2 MINOR MODIFICATIONS TO THE PROJECT

2.2 SUMMARY OF MODIFICATIONS TO THE PROJECT DESCRIPTION

DEIR/DEIS Exhibit 2-7

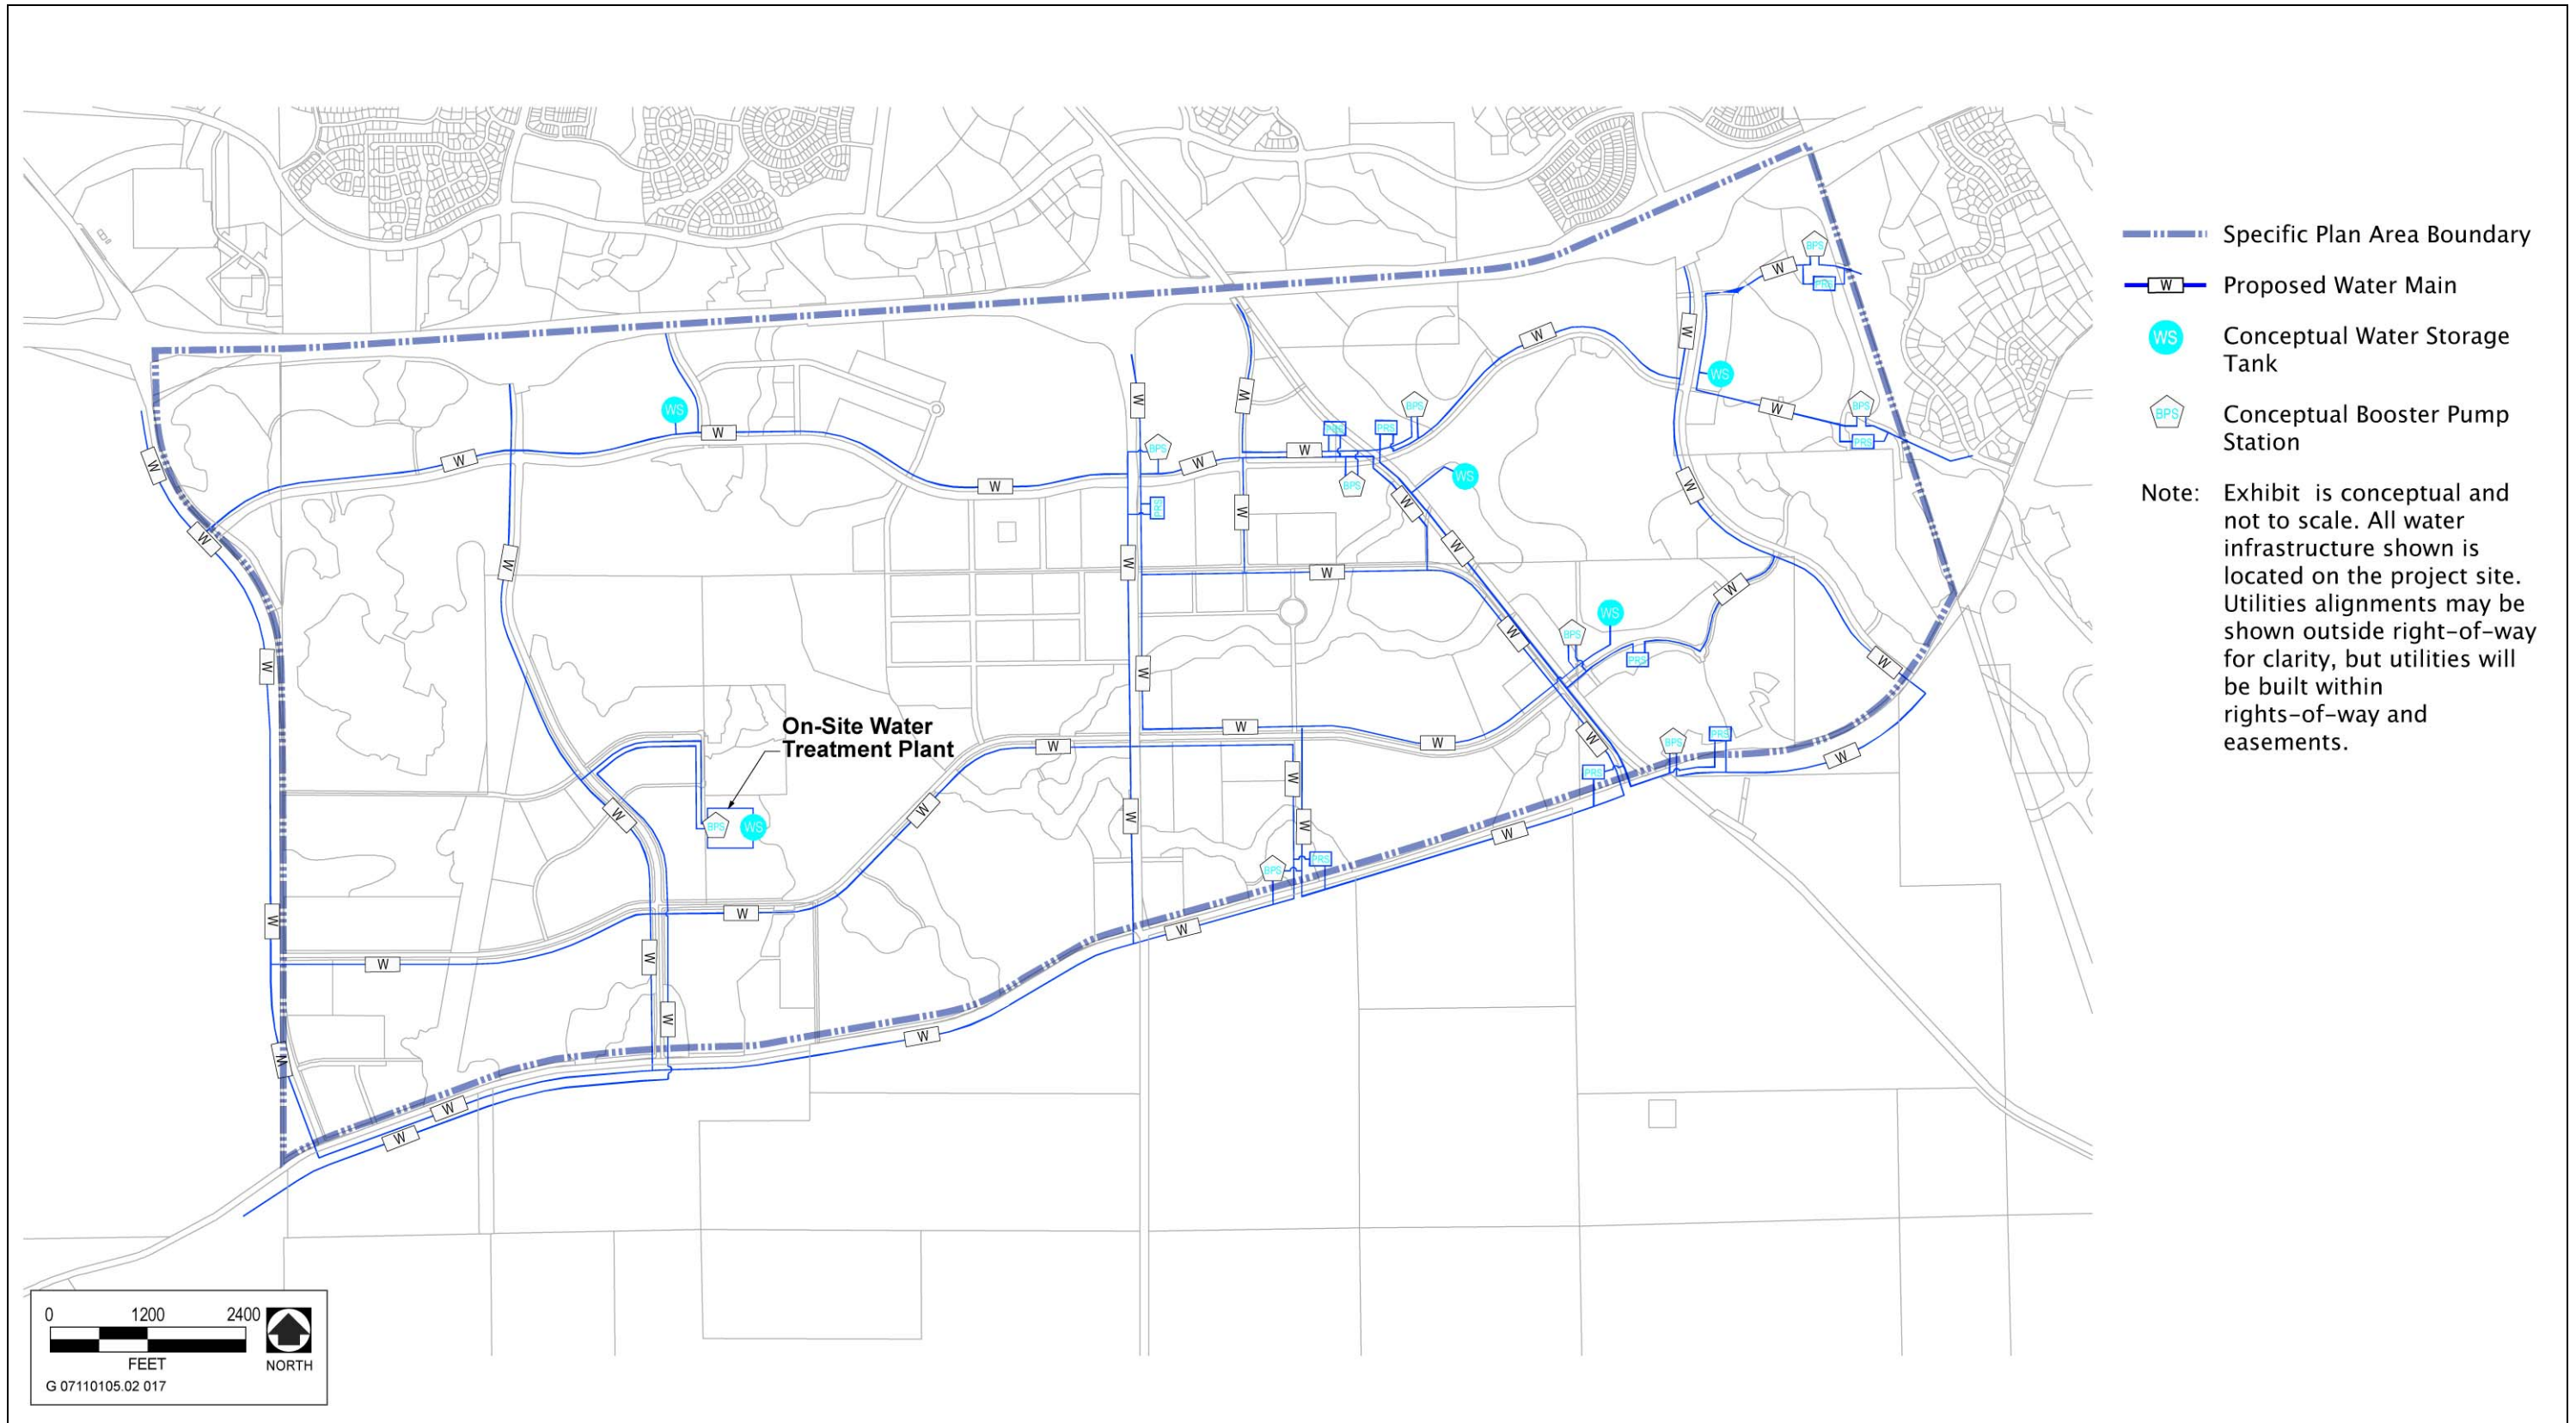
Since the DEIR/DEIS was prepared, the City has determined that its “preferred” location for the WTP is within the SPA at the location shown on DEIR/DEIS Exhibit 2-7 and as shown in Figure 12.1, “Backbone Water and Nonpotable Water Infrastructure” in the Folsom Plan Area Specific Plan, attached as Appendix N to the DEIR/DEIS.

Exhibit 2-3A

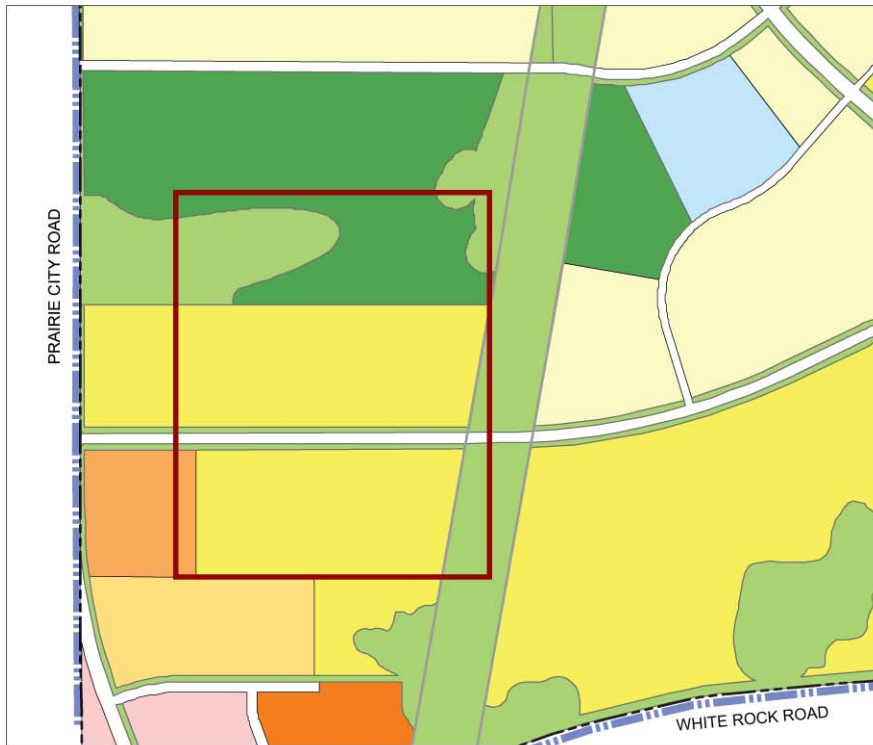
The Conceptual Land Use Plan presented in Exhibit 2-3 of the DEIR/DEIS has been altered slightly for the proposed Community Park West in the vicinity of “Area 40,” on the southwestern portion of the SPA. Exhibit 2-3A, below, provides a comparison of the land use plan for the Area 40 vicinity as presented in the DEIR/DEIS, and the revised land use plan. The proposed land use changes would add about 3.5 acres of Park, about 18 acres of Open Space, and about 23 acres of Single Family designation compared to the acreages in the Land Use Plan presented in the DEIR/DEIS. The acreage of the Single Family High Density designation would be reduced by about 39 acres, Multi-family Low Density would be reduced by about 5 acres, and Multi-family Medium Density would be reduced by less than 1 acre compared to the Land Use Plan presented in the DEIR/DEIS. (Totals may not be equal due to rounding and changes to the right-of-way needed for Street “A.”) These proposed changes represent an overall reduction in density and intensity compared to the land use plan described in the DEIR/DEIS, and therefore would not increase level of impacts beyond those evaluated throughout the DEIR/DEIS, nor would any new impacts occur.
